Subject: New remote control kit PN: P30120

Date: 7. Nov. 2007

New
P30115 Panel with RJ45 connector

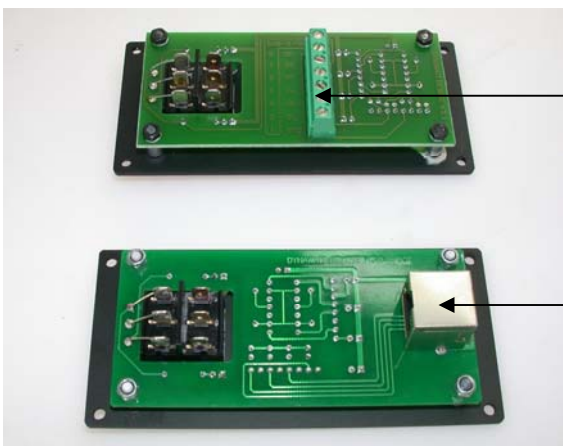
The new remote control kit will be available immediately. We have changed the connector clamp on the back side of the remote control to a RJ45 connector.

This will allow to use any standard shielded RJ45 cable to connect the remote control to the control unit. This kit will fit all units. We did not change to SUB D9 connector on the control unit. A special adapter SUB D9 – RJ45 will be supplied with the remote kit including as 7m long RJ45 cable.
